S U B M I S S I O N S R E P O R T

Integra Open Cut Project

March 2010

URS

Figure 5-4 Year 1 Revised Layout

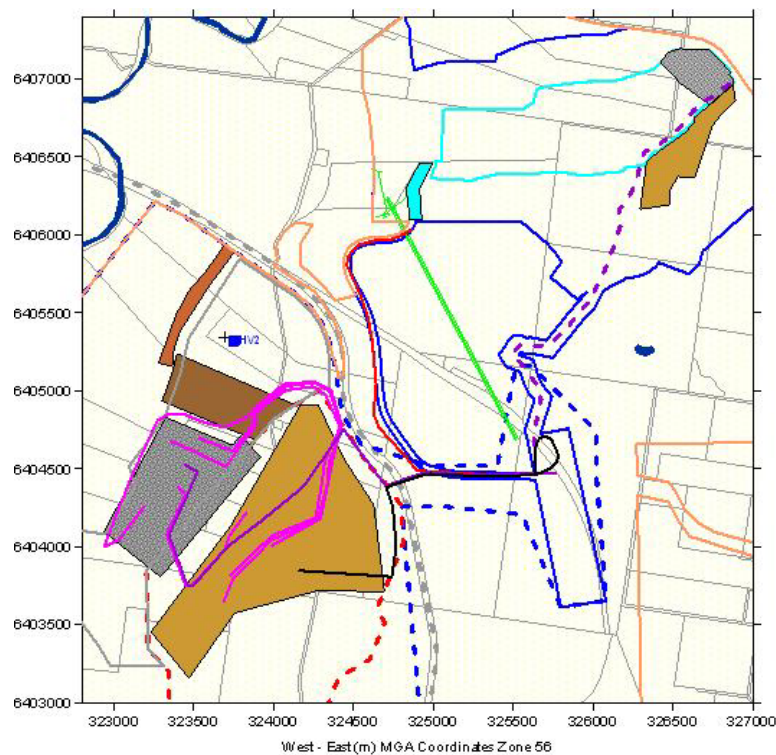
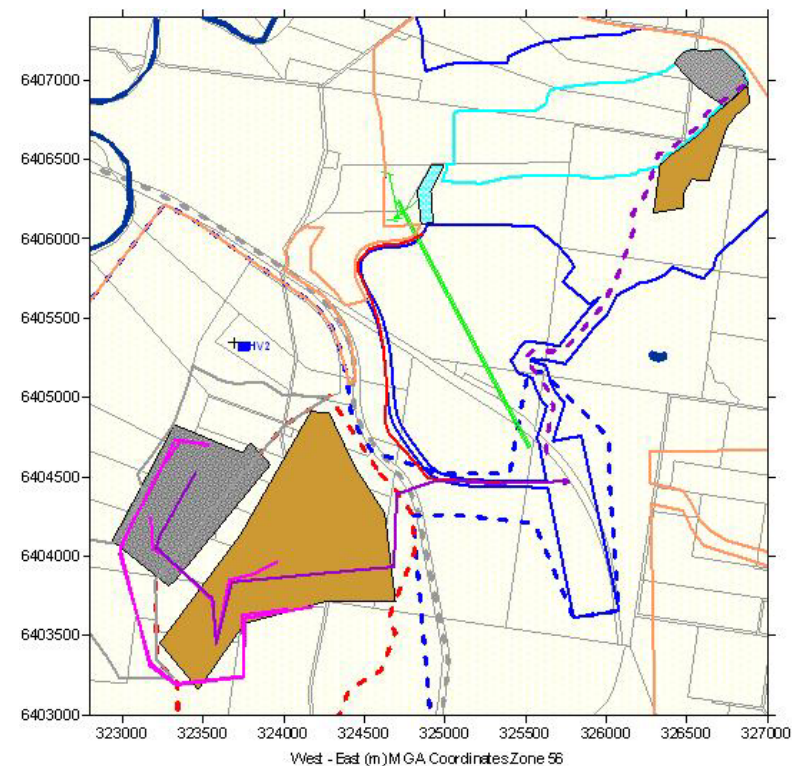
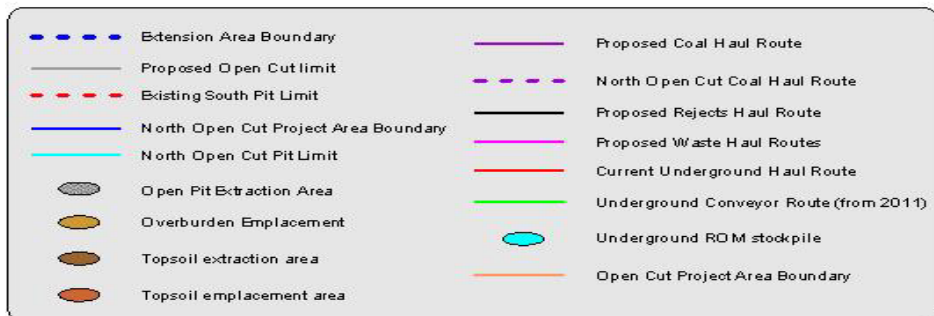
- managed such that if the prevailing direction of significant dust-generating wind is identified to be unfavourable to Residence 153, operations would be modified; and

- expedited vegetation of the bund.
